<b>ADDRESSEES</b>	: Owners and operators of coaches listed under “Application” ABC Customer Care and Parts Source
<b>VEHICLE MODEL</b>	: CX35 MY2020, CX45 MY2020
<b>MANUAL SECTION</b>	: 08.02 Climate control – control system
<b>BULLETIN TYPE</b>	: <b>Field Change Program</b>
<b>DATE</b>	: September 03th, 2020
<b>SUBJECT</b>	: <b>Optimization of driver’s cab climate control system operation</b>
<b>TERMS &amp; CONDITIONS</b>	: Refer to the warranty section further in this Bulletin.

The Field Change Program, subject of this bulletin, is applicable to:

CX35 MY2020	49983→49999, 83001→83024
CX45 MY2020	81456→81465, 81471→81503

Figure 7

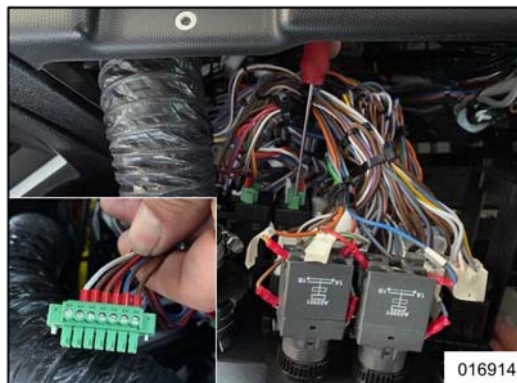
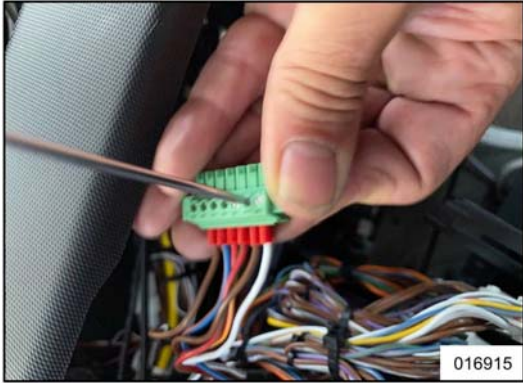
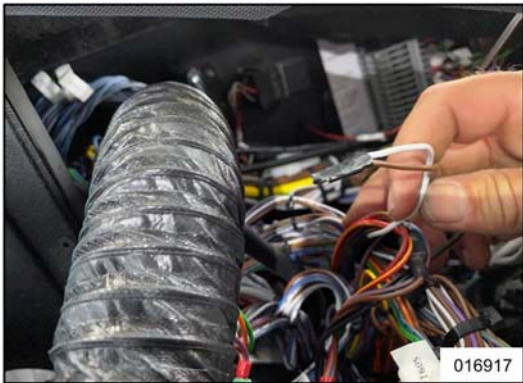
5

Remove the connector of the temperature control potentiometer.
